Title - Sujet Redev. of Floor B1 -Sinclair Centre	
Solicitation No. - N° de l'invitation EZ899-122573/A	Amendment No. - N° modif. 003
Client Reference No. - N° de référence du client	Date 2012-02-22
GETS Reference No. - N° de référence de SEAG PW-\$PWY-020-6584	
File No. - N° de dossier PWY-1-34396 (020)	CCC No./N° CCC - FMS No./N° VME
Solicitation Closes - L'invitation prend fin at - à 02:00 PM on - le 2012-02-29	Time Zone Fuseau horaire Pacific Standard Time PST
F.O.B. - F.A.B. Plant-Usine: <input type="checkbox"/> Destination: <input checked="" type="checkbox"/> Other-Autre: <input type="checkbox"/>	
Address Enquiries to: - Adresser toutes questions à: Ly, Ronny(PWY)	Buyer Id - Id de l'acheteur pwy020
Telephone No. - N° de téléphone (604) 666-0043 ()	FAX No. - N° de FAX (604) 775-6633
Destination - of Goods, Services, and Construction: Destination - des biens, services et construction: Services Canada - Sinclair Centre, Vancouver, B.C.

This Amendment 003 is raised to incorporate Addendum No. 2.

ADDENDUM #2

NEW FEATURE WALL
 ELEVATION SCALE: 1:100

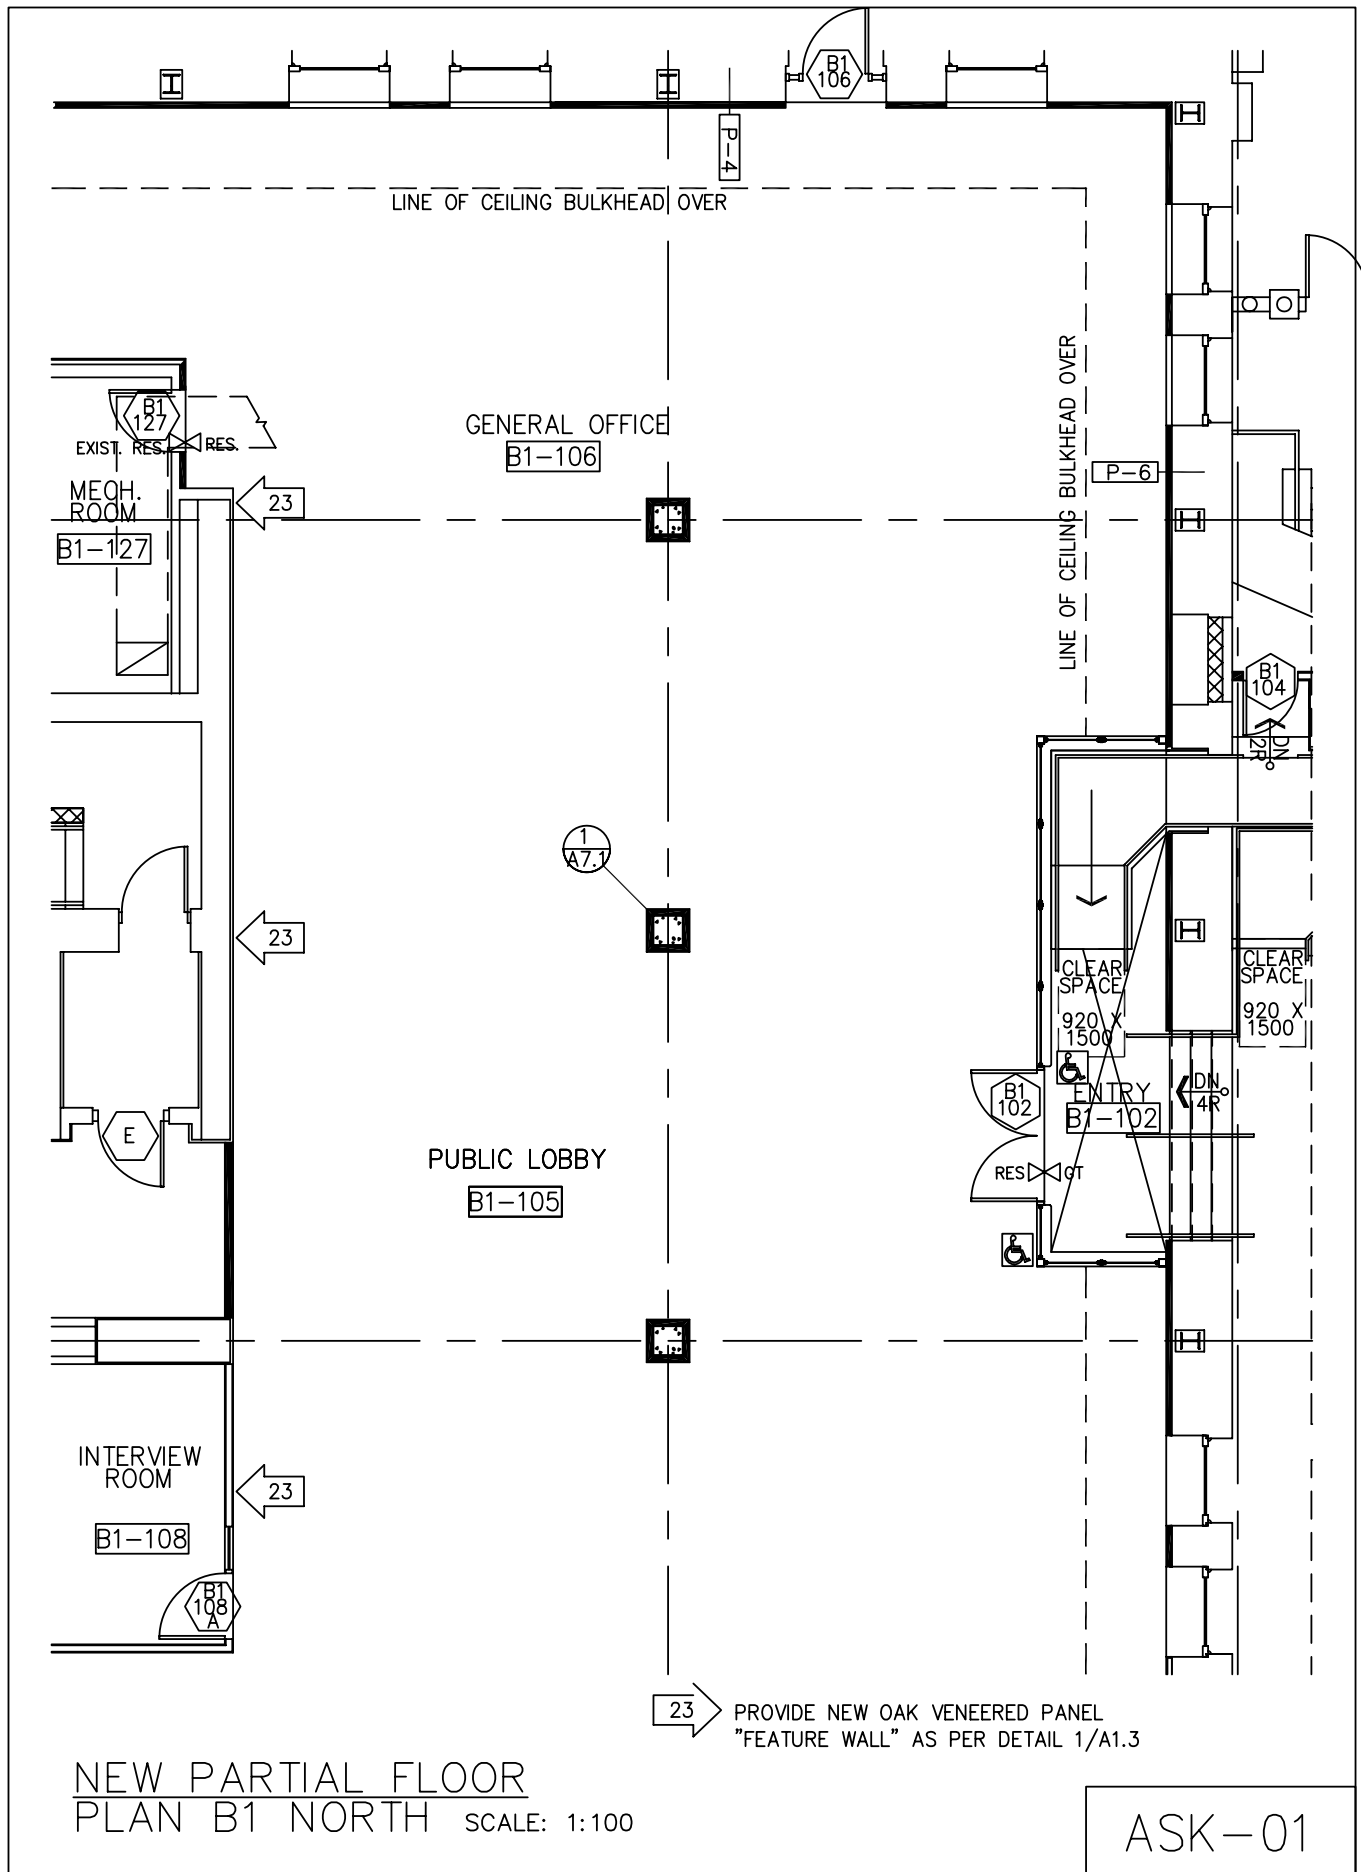
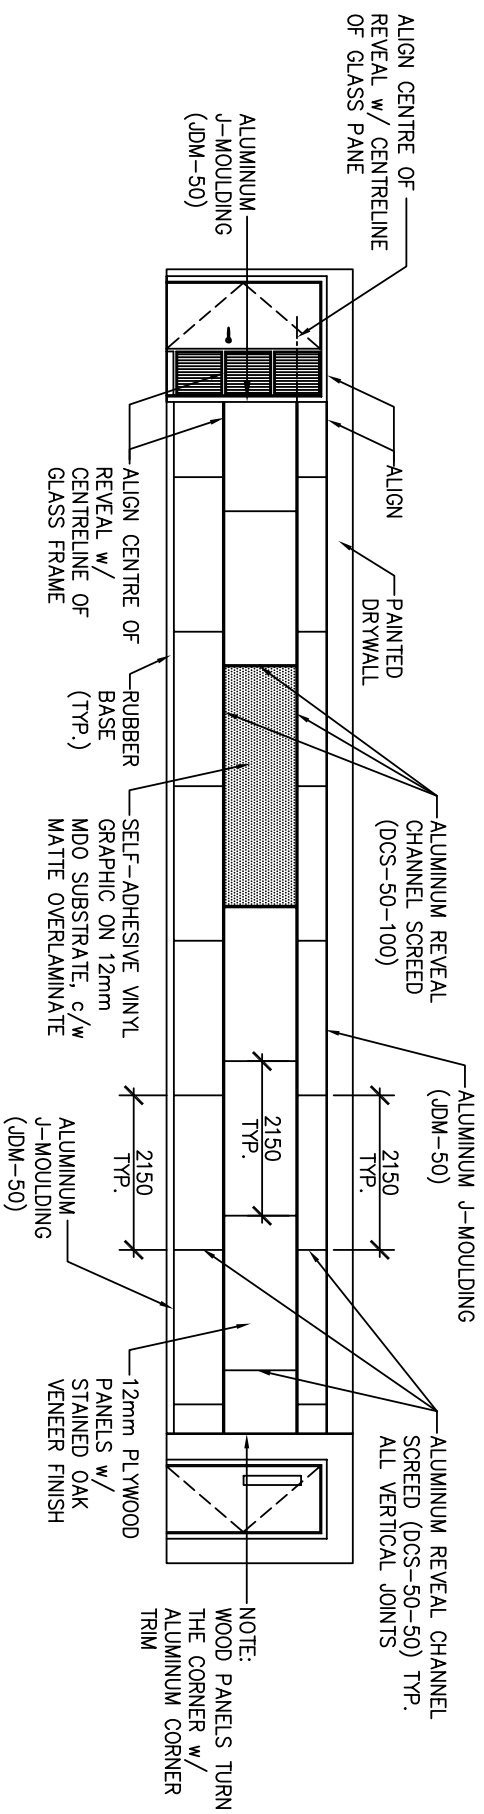
2. Drawing A1.3:
Construction Notes, Add note 23 to read as follows:

"23 Provide new oak veneered panel 'feature wall' as per detail 1/A1.3."

4. Drawing A1.3:

Add detail "1" as per attached sketch ASK-02.
